SERVICE PROCEDURE

G-06506-R1

SUBJECT: SAFETY RECALL (U.S., EXPORT)

**SR-7™ SPRING BRAKE MODULATING VALVE on
certain 4000 and 7000 Models built 4/6/2006 thru
6/9/2006**

Figure 2 - LOCATION OF IDENTIFICATION CODES

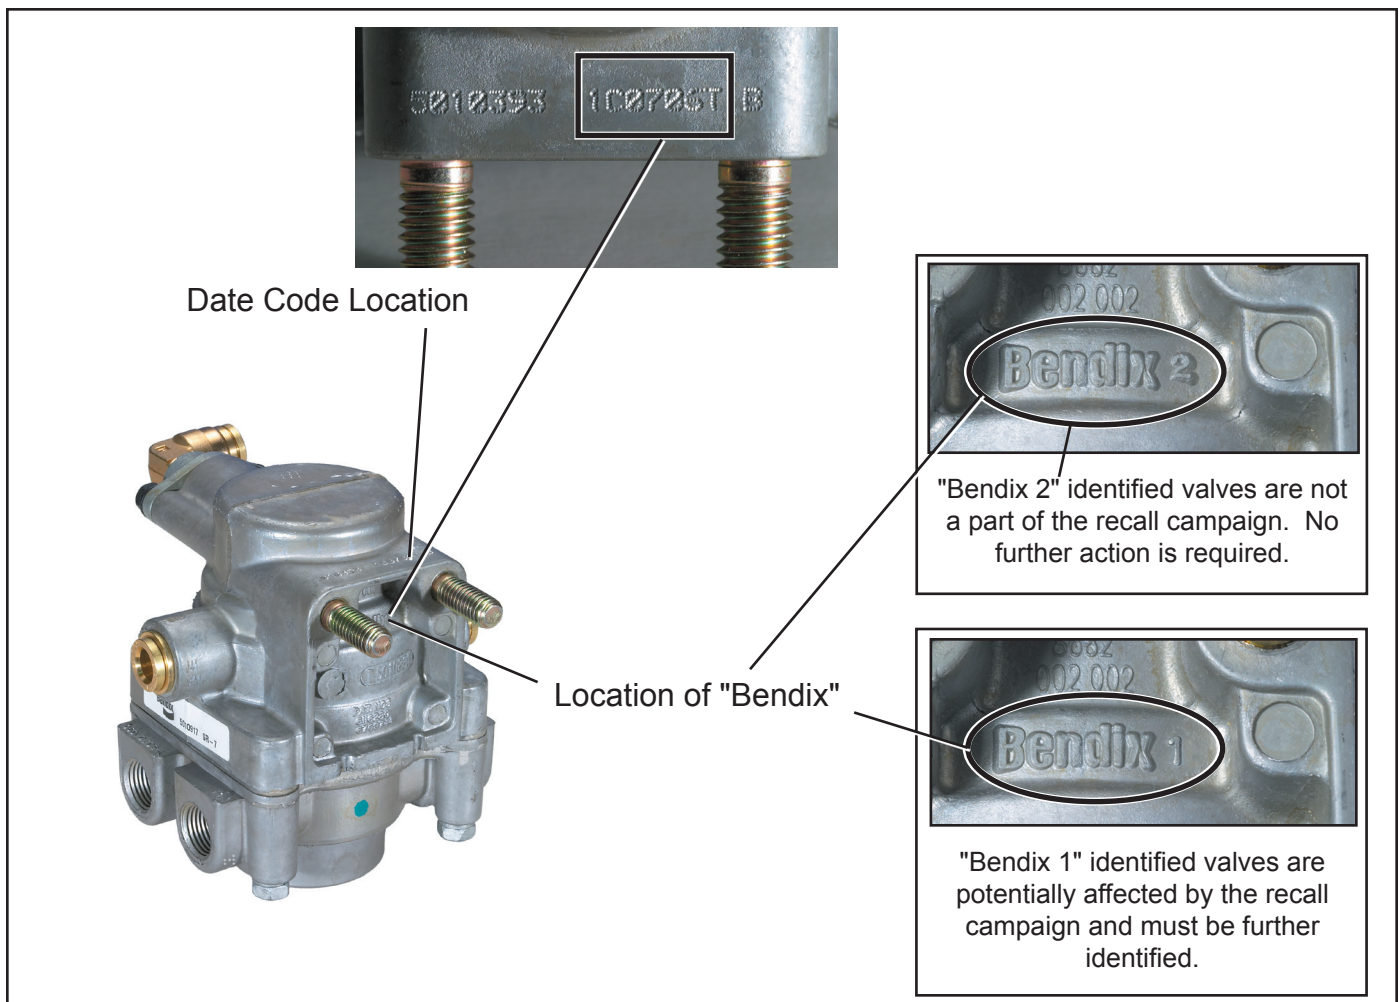
Refer to Figure 2 for valve identification.

1. Locate the SR-7™ valve on the vehicle. Typically it is located near the rear axle mounted on the frame rail.
2. On the mounting stud side of the valve look for "Bendix" cast into the valve body. If the valve needs to be removed to properly see this portion of the body, remove per the Valve Removal section of this document.

3. If the casting has "Bendix 2" on the side, it is not affected by the recall campaign and no further action is required.
4. If the casting has "Bendix 1" on the side, it is potentially affected by the recall campaign and must be further identified.
5. To further identify the valve, locate the manufacture date code on the top of the valve. Vehicle paint may need to be removed to identify the date code. SR-7™ valves with the casting code "Bendix 1" manufactured between April 1, 2006 and May 24, 2006 are subject to the recall campaign and must be replaced. Interpret the manufacturing date code to identify if the valve is subject to the recall.

6. If the valve date code does not fall within the dates of April 1, 2006 (D0106) and May 24, 2006 (E2406) inclusive, then no further action is needed.
7. **If the SR-7™ valve has a casting code "Bendix 1" and was manufactured between April 1, 2006 and May 24, 2006 it is subject to the recall campaign and must be replaced.**
